ADDENDUM NO. 1

CONTRACT NO. 2011-FT-3

LARKSPUR FERRY TERMINAL UTILITY REHABILITATION

ADDENDUM NO. 1
CONTRACT NO. 2011-FT-3, LARKSPUR FERRY TERMINAL
UTILITY REHABILITATION

UTILITY REHABILITATION PLAN
SCALE: 1"=25'

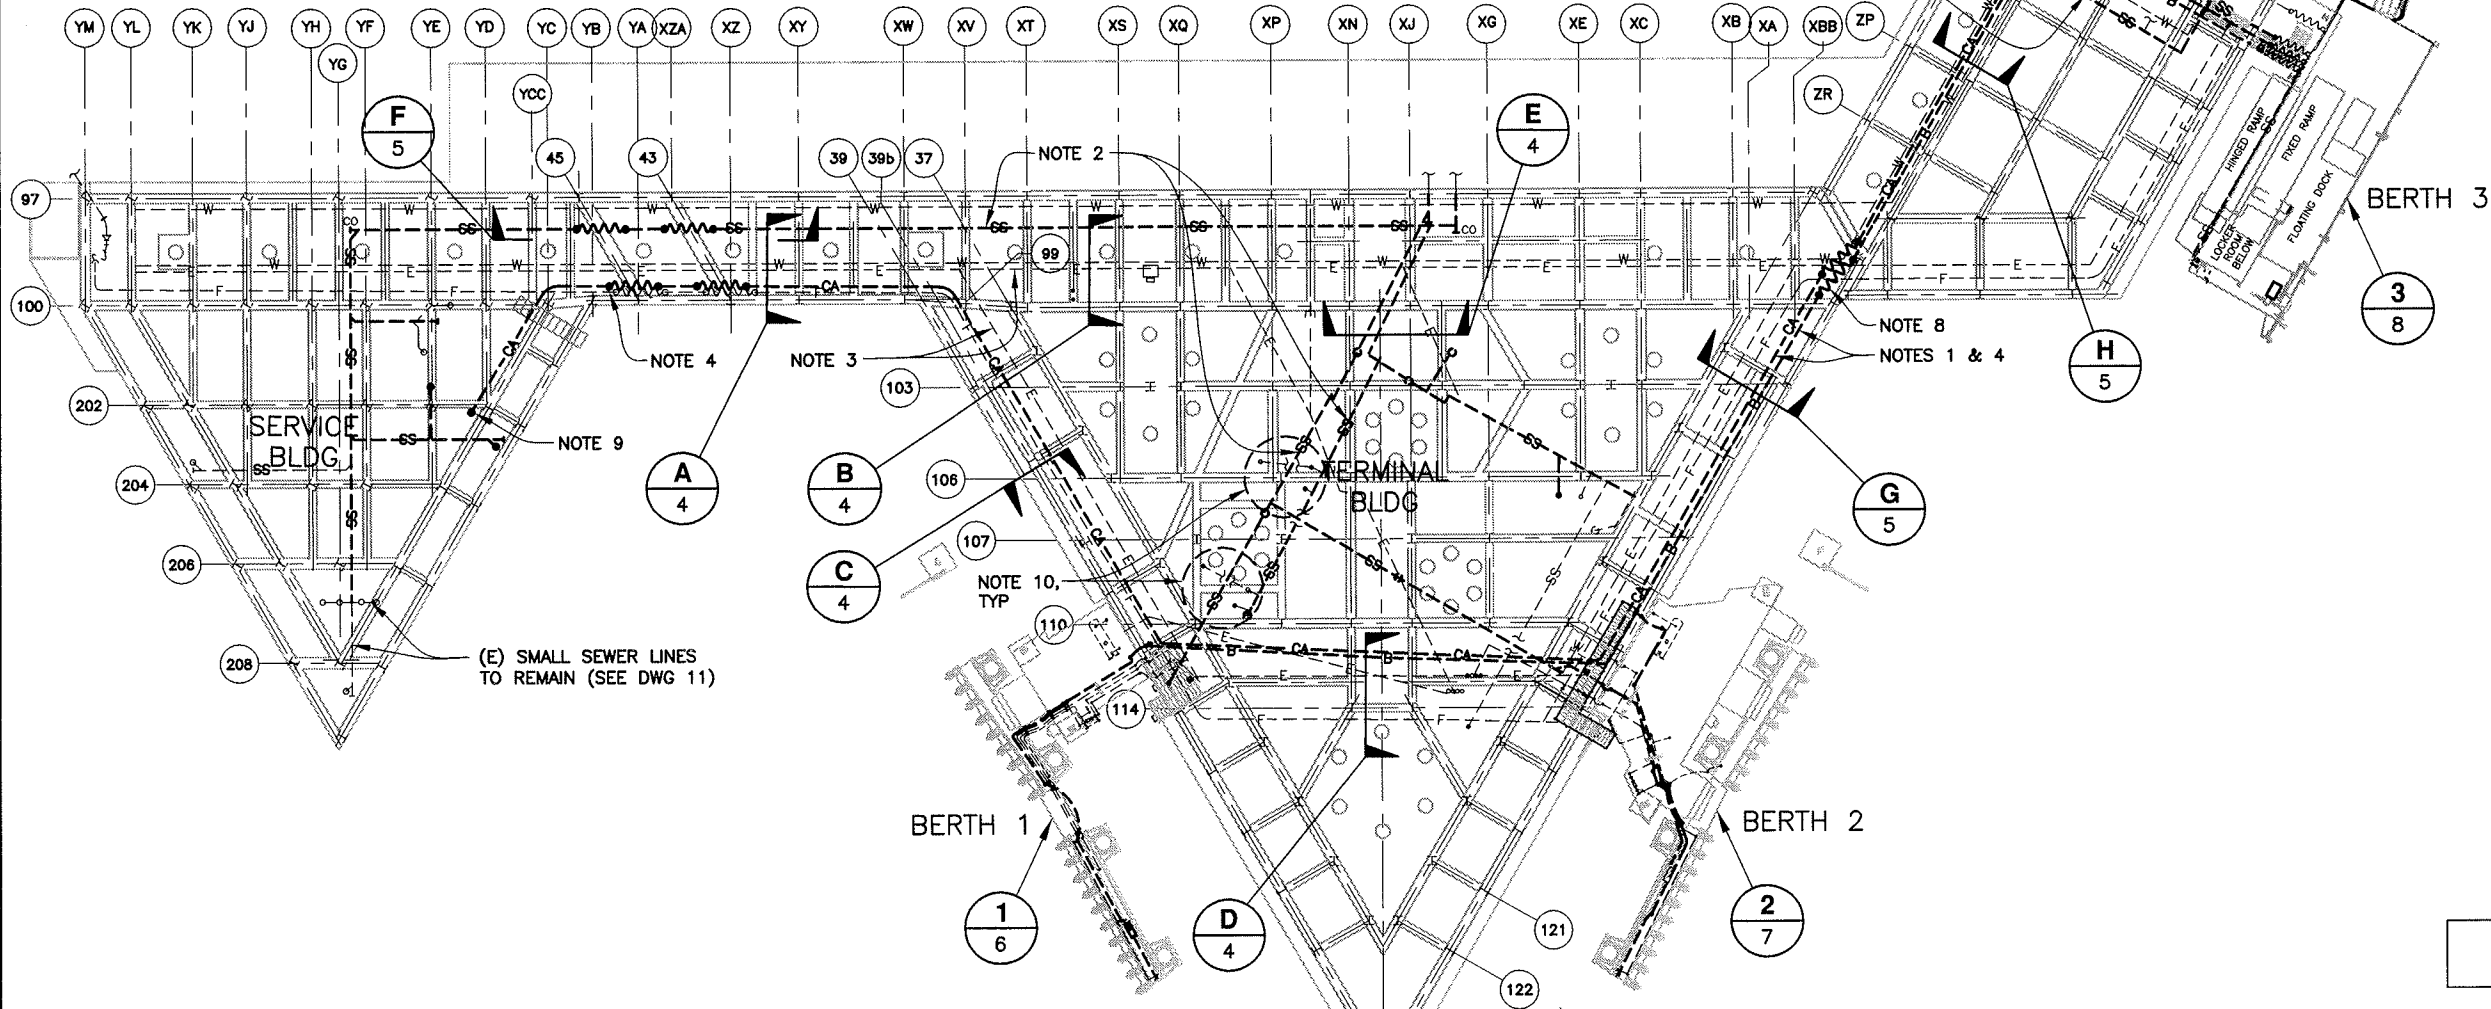
1. **REPLACE** Drawings Nos. 3, 10, 11, and 16 with the revised drawings attached. Revisions are "bubbled" and denoted with triangular symbols marked "1."
